The Commission has issued the enclosed Amendment No. 54 to Facility Operating License No. NPF-2 and Amendment No. 45 to NPF-8 for the Joseph M. Farley Nuclear Plant, Unit Nos. 1 and 2, respectively. The amendments consist of changes to the Technical Specifications in response to your application transmitted by letter dated June 25, 1984, supplemented September 24, 1984.

The amendments modify the Technical Specifications, Section 6, Administrative Controls, to reflect two Assistant Plant Managers; one responsible for overall plant operations and the other responsible for overall plant administration.

JOSEPH M. FARLEY NUCLEAR PLANT, UNIT NO. 1

SAFETY EVALUATION BY THE OFFICE OF NUCLEAR REACTOR REGULATION
RELATED TO AMENDMENT NO. 54 TO FACILITY OPERATING LICENSE NO. NPF-2
AND AMENDMENT NO. 45 TO FACILITY OPERATING LICENSE NO. NPF-8

Figure 6.2-2 Facility Organization

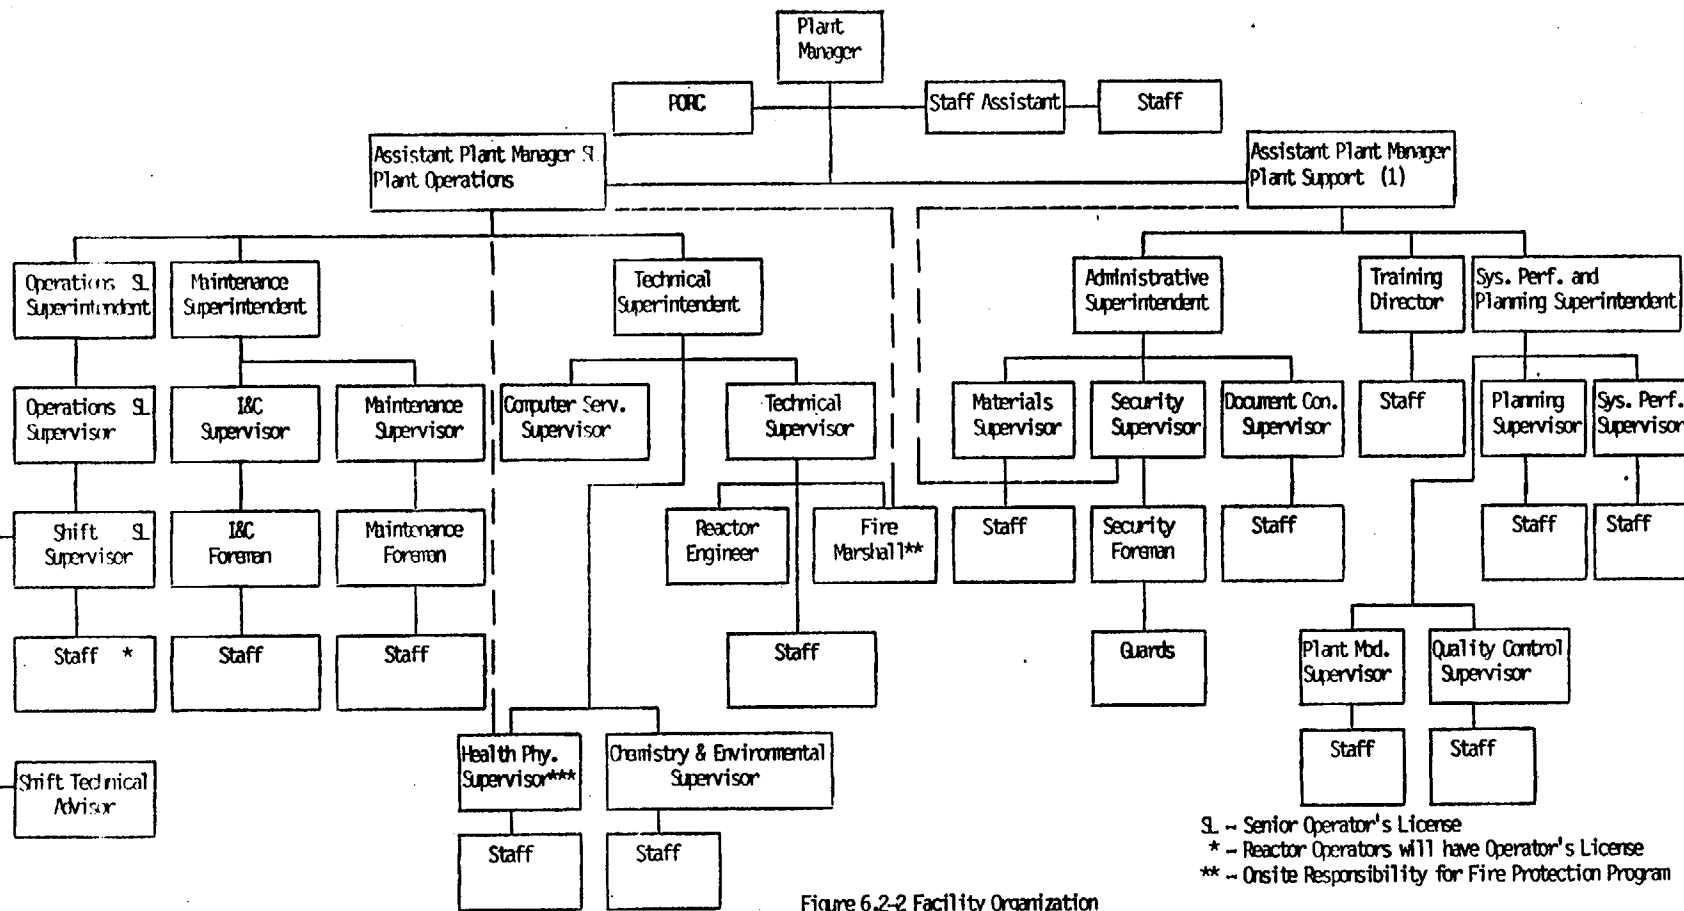
Following discussions between the Commission staff and the APCo staff the licensee proposed a clarification by letter dated September 24, 1984 to the staffing table in Figure 6.2-2 of the Technical Specifications to add a footnote #1 referencing the Assistant Plant Manager-Plant Support. Footnote #1 states that "The person filling this position may act as the Plant Manager, provided this person meets the requirements of ANSI N18.1-1971 Section 4.2.1, FSAR Section 13.1.3.1.1, and has completed Emergency Director Training." In addition, the licensee has agreed to amend the Farley FSAR and plant procedure references to the Assistant Plant Manager assuming responsibility for normal or emergency plant operations, or replacing the Plant Manager, to normally specify Assistant Plant Manager-Plant Operations, an SRO licensed position.

(1) The person filling this position may act as the Plant Manager, provided this person meets the requirements of ANSI N18.1-1971 Section 4.2.1, FSAR Section 13.1.3.1.1 and has completed Emergency Director Training.

Figure 6.2-2 Facility Organization

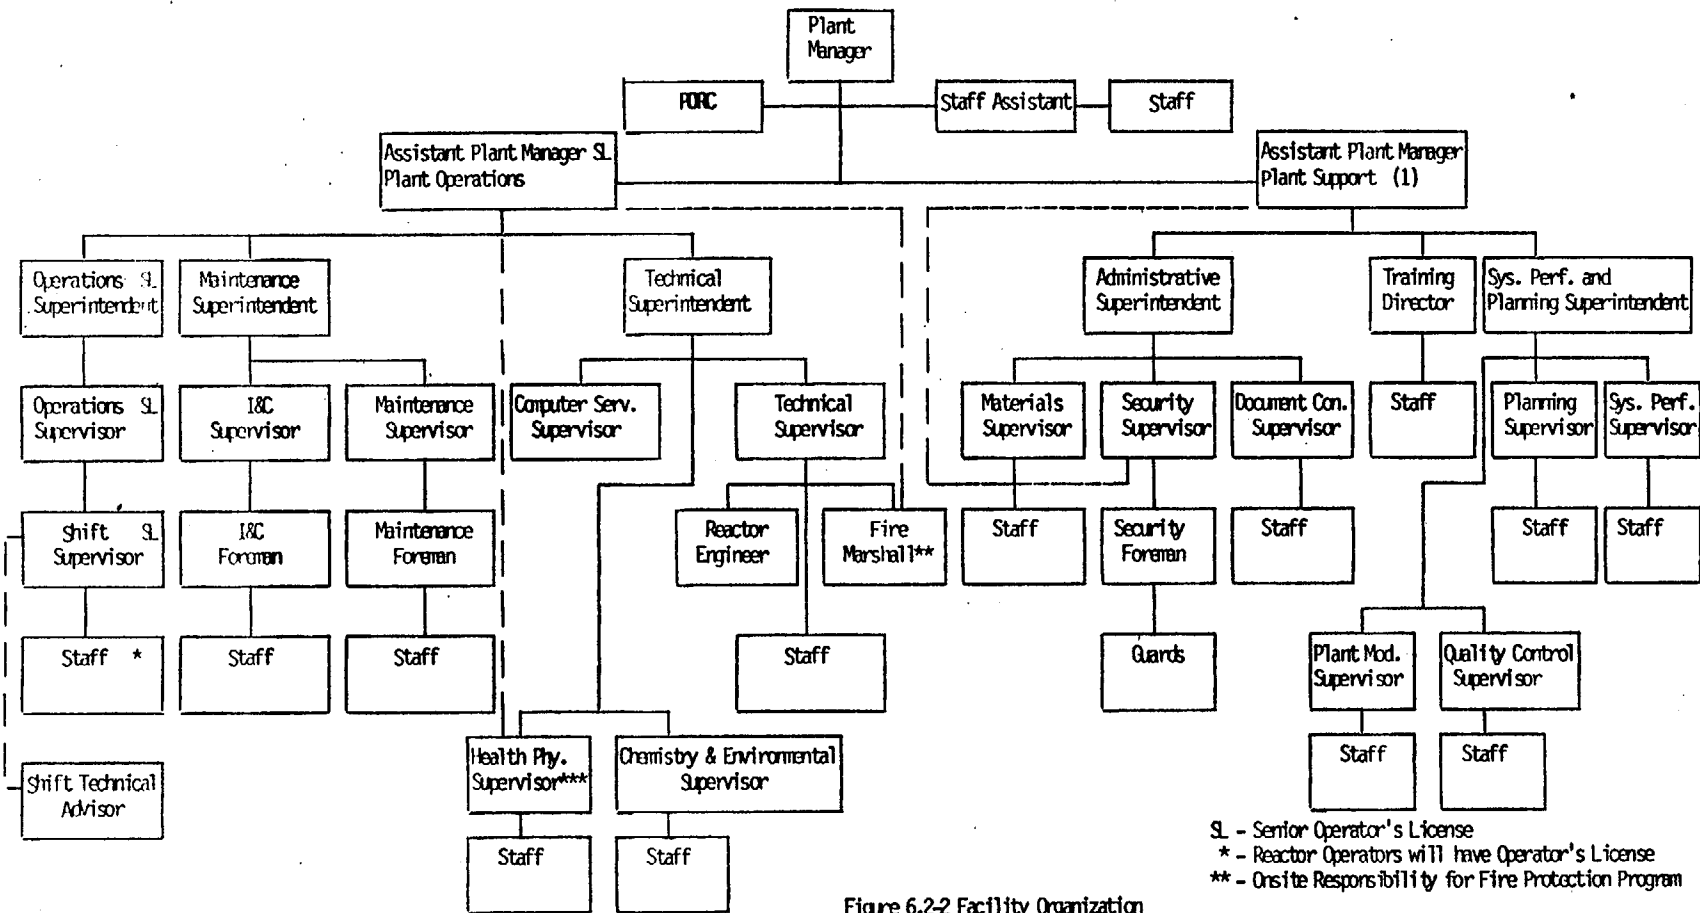
The amendments modify the Technical Specifications, Section 6, Administrative Controls, to reflect two Assistant Plant Managers; one responsible for overall plant operations and the other responsible for overall plant administration.

(1) The person filling this position may act as the Plant Manager, provided this person meets the requirements of ANSI N18.1-1971 Section 4.2.1, FSAR Section 13.1.3.1.1 and has completed Emergency Director Training.
